Origination Form
Proposed Revisions to a Standard Plans Index

Originator:	Turley, Joshua	Index Number:	521-660
Date:	5/14/2024	Sheet Number(s):	2, 4
E-mail:	Joshua.Turley@dot.state.fl.us	Index Title:	LIGHT POLE PEDESTAL - BRIDGE

OPTION 2 - TYPICAL SECTION AT LIGHT POLE PEDESTAL (Approach Slab Similar)

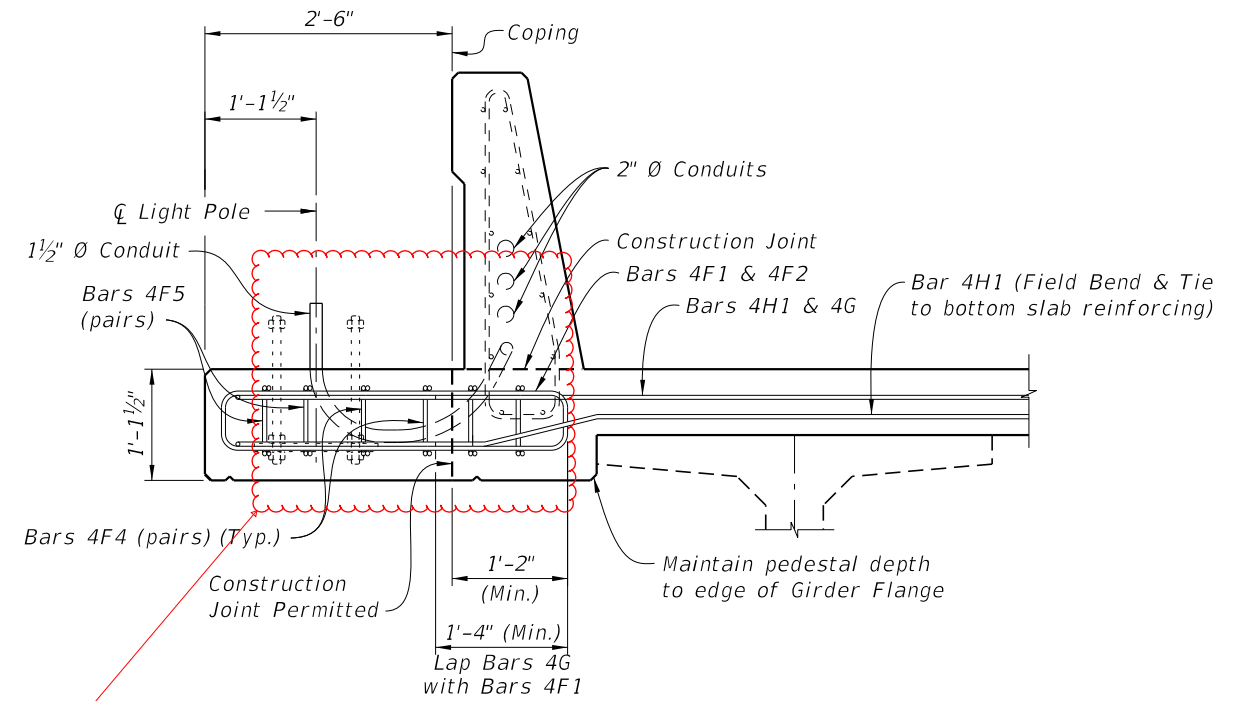
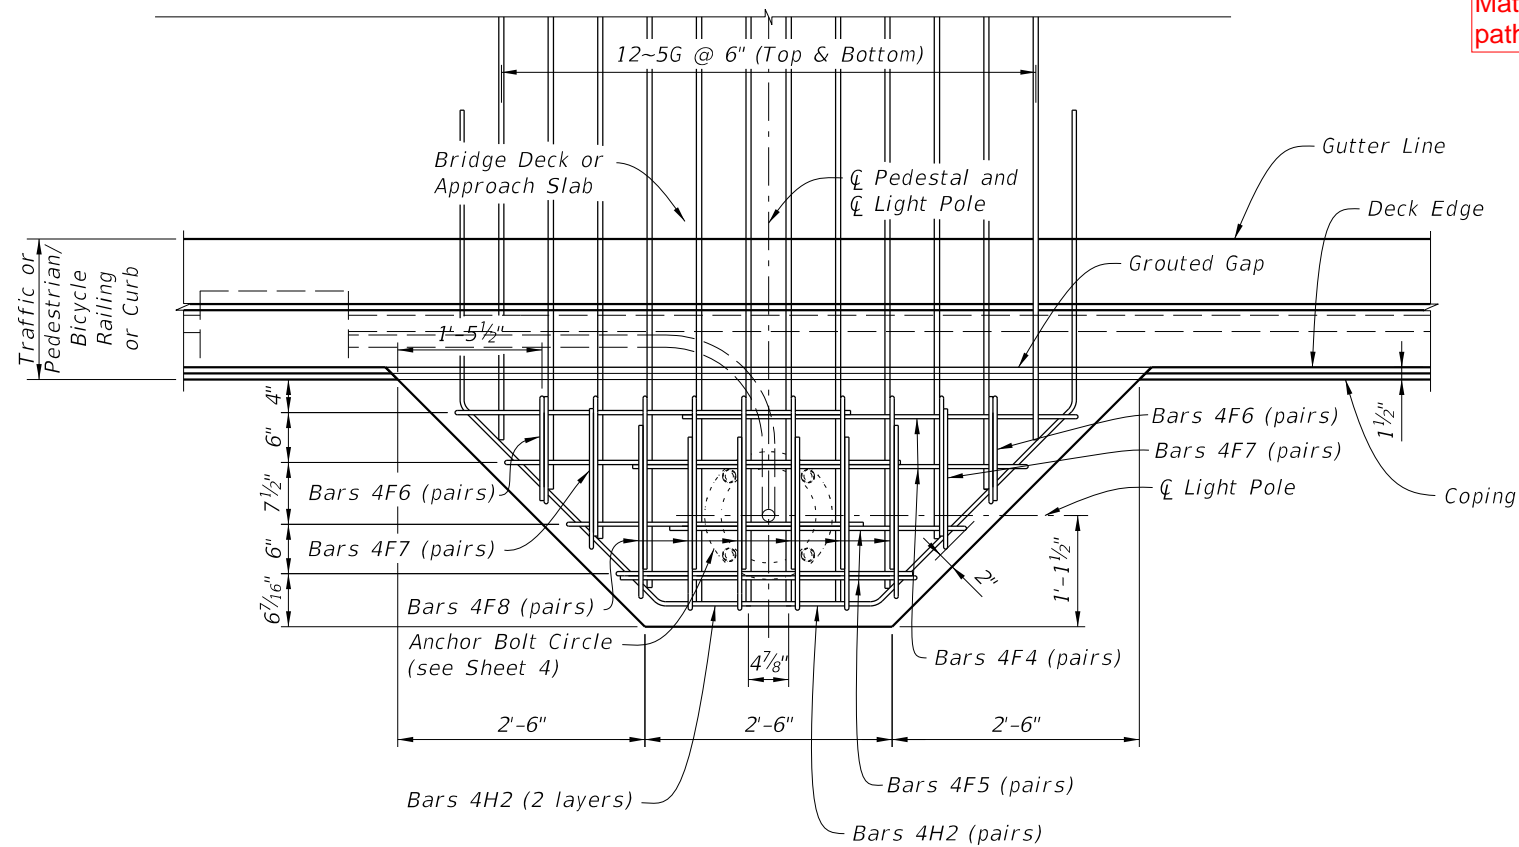
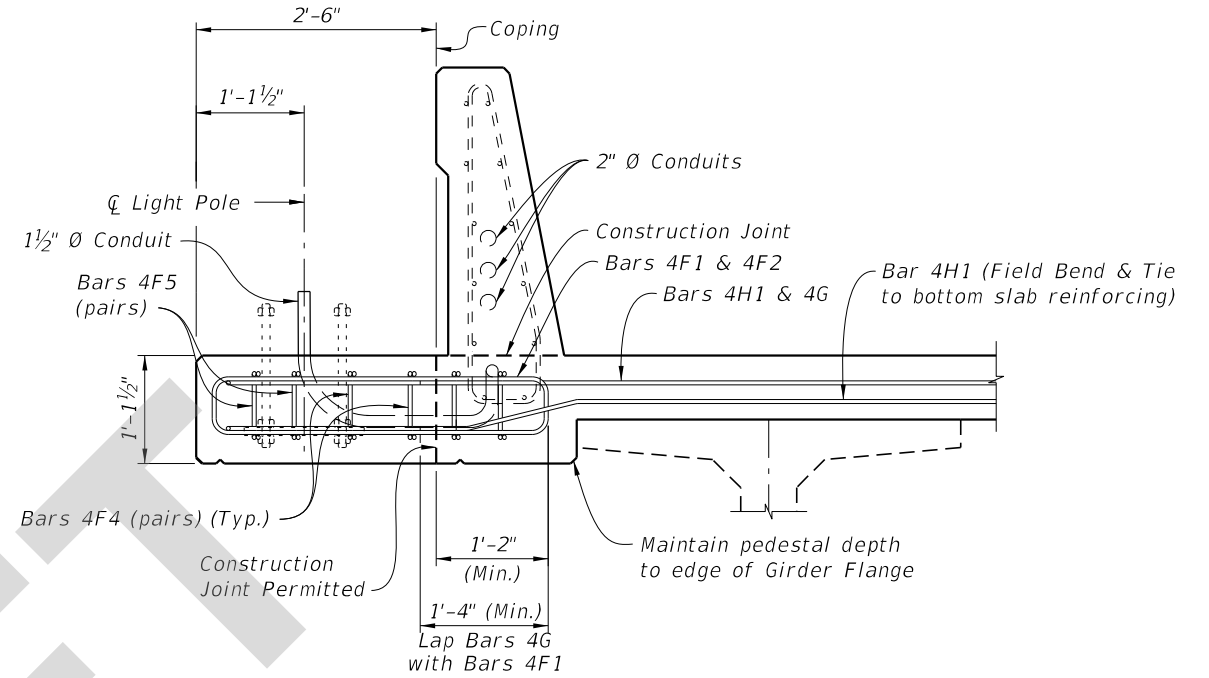
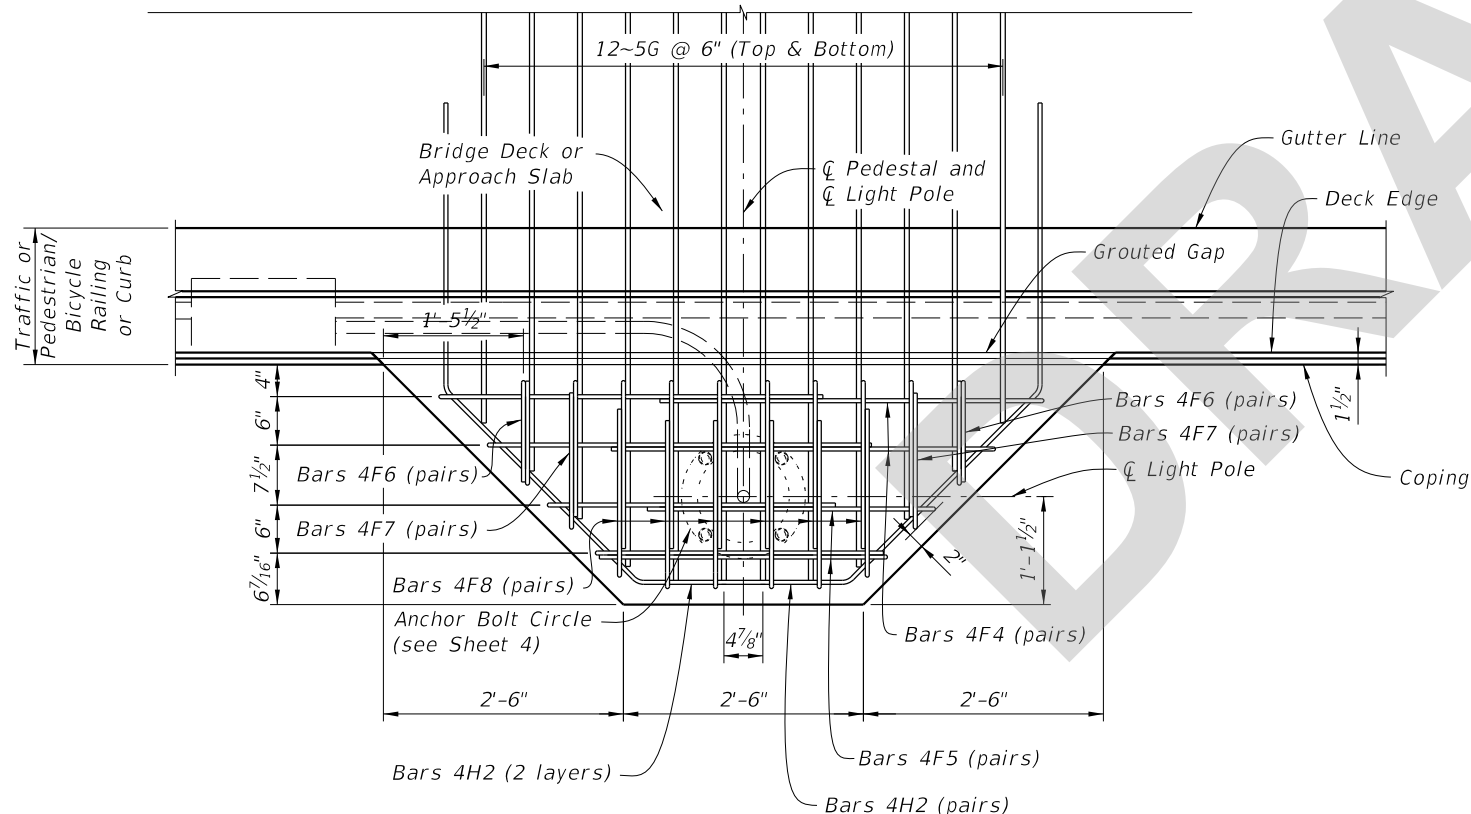
Sheet 2: Revised conduit path for the TYPICAL SECTION's.
 Sheet 4: Labeled the anchor bolt nuts in DETAIL "A"; Eliminated the anchor bolt table and updated corresponding notes. Added "Note: Min. anchor bolt embed is 9 1/2". Max embed must maintain min. required bottom cover. Anchor bolt; embed max. may be as long as required for constructability depending on which pedestal option is used."

Sheet 1: Conduit path was slightly incorrect so we fixed it.
 Sheet 4: We labeled the anchor bolt nuts to correspond with the Spec. We eliminated the anchor bolt table because it was from the ground application and gave the impression that all the configurations in the table were designed for for bridge mounted poles which was not the case.

Match the conduit curvature path of sheet 1 option 1.
